DEVELOPMENT APPLICATION ASSESSMENT REPORT

Application Number:	DA2023/1527
----------------------------	-------------

Responsible Officer:	Thomas Prosser
Land to be developed (Address):	Lot B DP 381427, 187 Riverview Road AVALON BEACH NSW 2107 Lot LIC 577827, 187 Riverview Road AVALON BEACH NSW 2107
Proposed Development:	Demolition of an existing dwelling and Construction of a new dwelling including a swimming pool and relocation of existing inclinator
Zoning:	C4 Environmental Living
Development Permissible:	Yes
Existing Use Rights:	No
Consent Authority:	Northern Beaches Council
Land and Environment Court Action:	No
Owner:	Vanessa Louise Lenthall
Applicant:	Vanessa Louise Lenthall

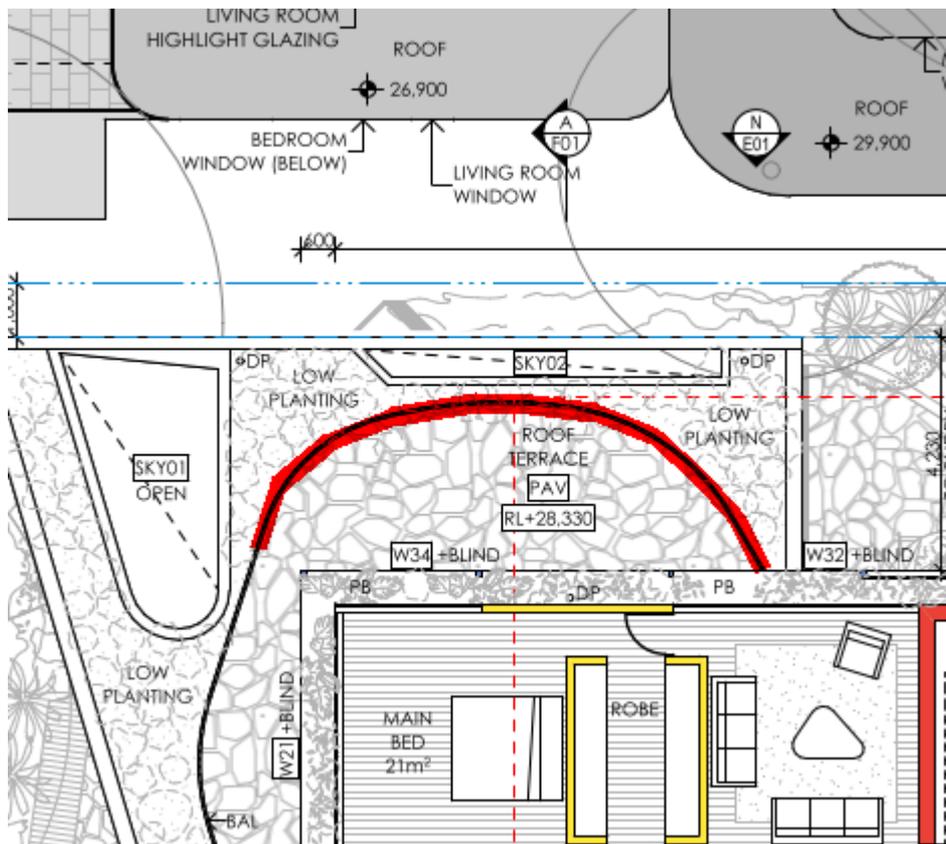
19. Amendments to the approved plans

The following amendments are to be made to the approved plans:

Alternatively, a planter box may be provided on the inside of the red line. The planter box is to have a minimum height of 1.4m, a minimum width of 1.5m, and planting that grows to a height of at least 1.8m above finished terrace level.
